# Chatham County, NC

**File #:** 22-4412 **Version:** 1

**Title:** Vote on a request by Ben Mayo, P.E. of Withers Ravenel on behalf of Windjam Development (RBV 1525, LLC) to approve for Subdivision First Plat review and approval of Flatiron Forest, consisting of 29 lots on 42.124 acres, located off Hamlets Chapel Rd (S.R. 1525), Parcel 2037.

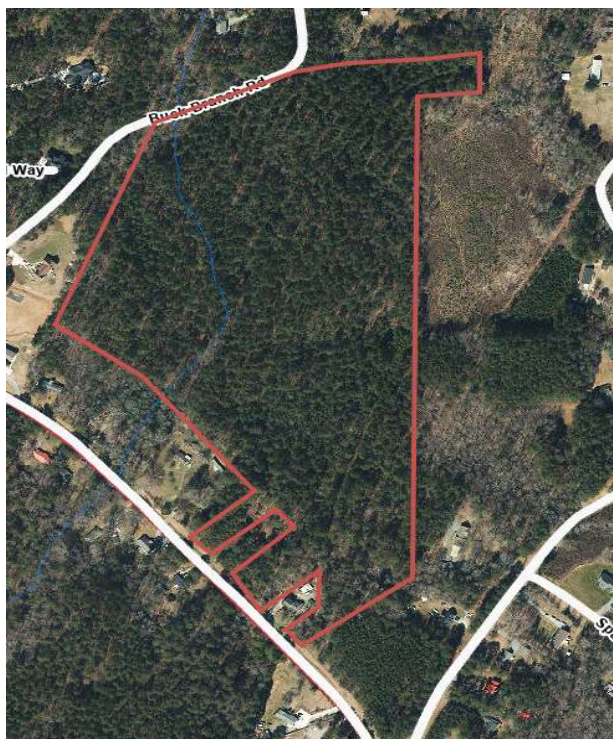
**Technical Review Committee:** The TRC met to review this project at their June 15<sup>th</sup> meeting. Planning staff informed the applicant that the minimum size for all the lots needed to be at least 40,000 square feet. The plat would need to be revised to show those changes and that has been done. Watershed staff said the plat was showing suitable soils within the buffer, which will need to be removed and that has been done. Also, staff raised concerns about lots 1,9, and 10 if they will have enough buildable areas with the septic area and buffers being show on those lots. Staff asked about the stormwater control measure (SCM) in front of lot 16 and if it was an easement or an open lot. Both SCMs would have their own open lot spaces. Watershed staff recommended extra care be taken in construction of the SCM because it was so close to a buffer.

There was some discussion if the applicant can make these changes before the July 5<sup>th</sup> Planning Board deadline. The new application and revised plats were provided to staff and have been included in the packets for the meeting.

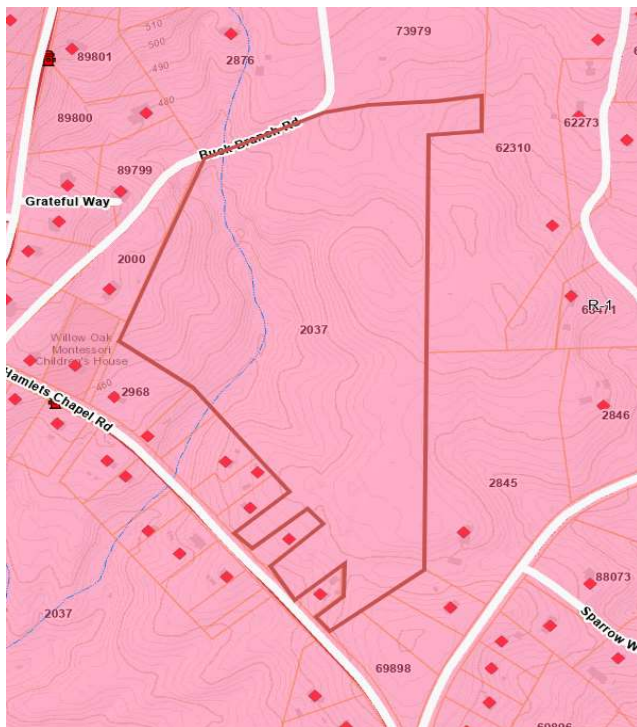
**Septic:** According to Environmental Health septic field layouts will be needed for 1,2,6,7,11,16,22,28, &29 depending on the amount of suitable soils that will be available once the house sites are located. Central Carolina Soil Consulting, PLLC submitted a soil/site evaluation to the applicant on December 11<sup>th</sup>, 2021. The report is attachment 7.
